**PLANNING COMMISSION REPORT
NON PUBLIC HEARING ITEM**

ITEM NO 3B: PRELIMINARY PLAT FOR 24TH PLACE ADDITION (SLD)

PP-15-00196: Consider a Preliminary Plat for 24th Place Addition, containing 1 7-acre lot for proposed neighborhood commercial development and 14 lots for residential duplex development, located at 4300 W. 24th Place. Submitted by BG Consultants, Inc., on behalf of RPI LLC, property owner of record.

Figure 1: Proposed Development Concept

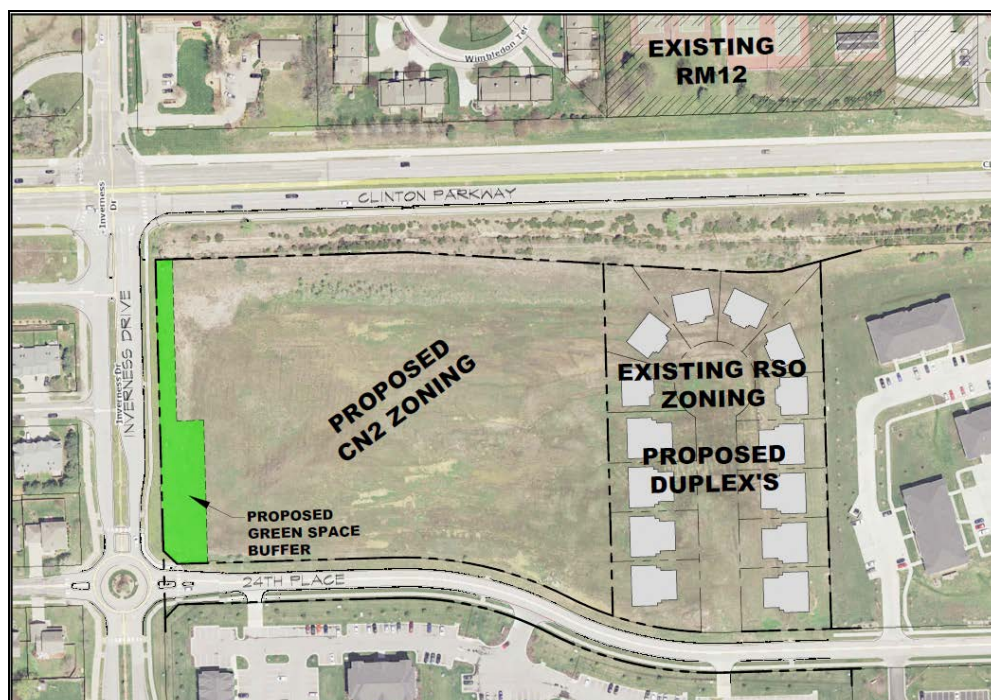
The applicant's submission materials indicate that they intend for a 65' buffer along the south half of the Inverness Drive frontage.

Figure 2: Previous Development Concept

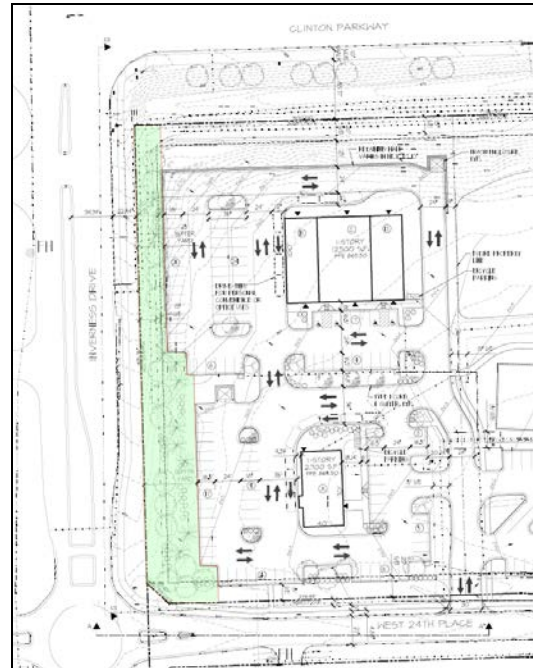
The previous development application for a three acre commercial development with a drive-thru (SUP-14-00026) showed a 50' buffer yard along this same area. The following design accommodates drive thru traffic, as proposed in the previous application.

Figure 3: Optional Development Concept

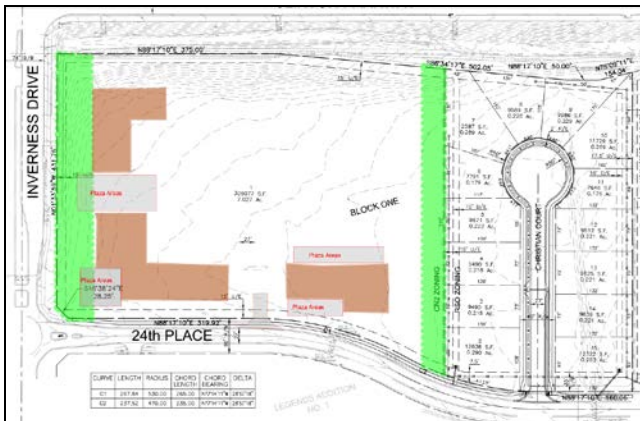
Another example of this development pattern, with an established buffer yard, is shown below. This option provides an example of buildings oriented to the street with plaza areas located adjacent to the buffer areas that provide a transition from the buffer area to the commercial area. This particular example does not include a drive-thru option but is intended to illustrate the relationship of the Inverness Drive buffer yard to the commercial development.

PRELIMINARY PLAT

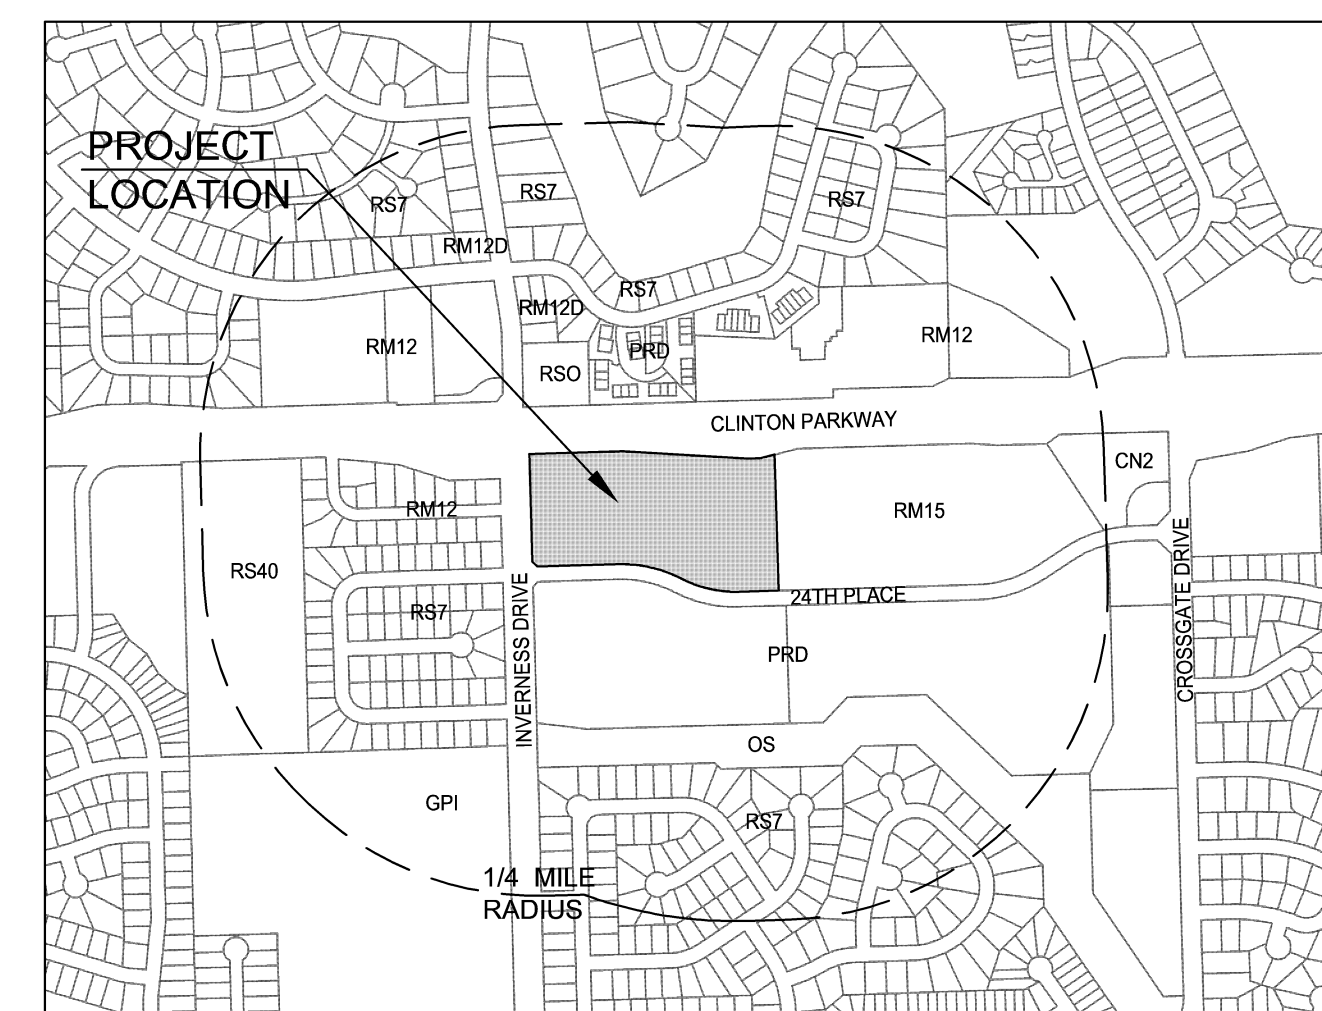
1. Revise Preliminary Plat to show a minimum building and parking setback along Inverness Drive of at least 65' along the southern 350' of frontage to extend to the rear lot lines of the dwellings on the north side of Adams Avenue.
2. Provision of a note on the face of the plat that states the setback does not apply to accessory structures or pedestrian amenities.
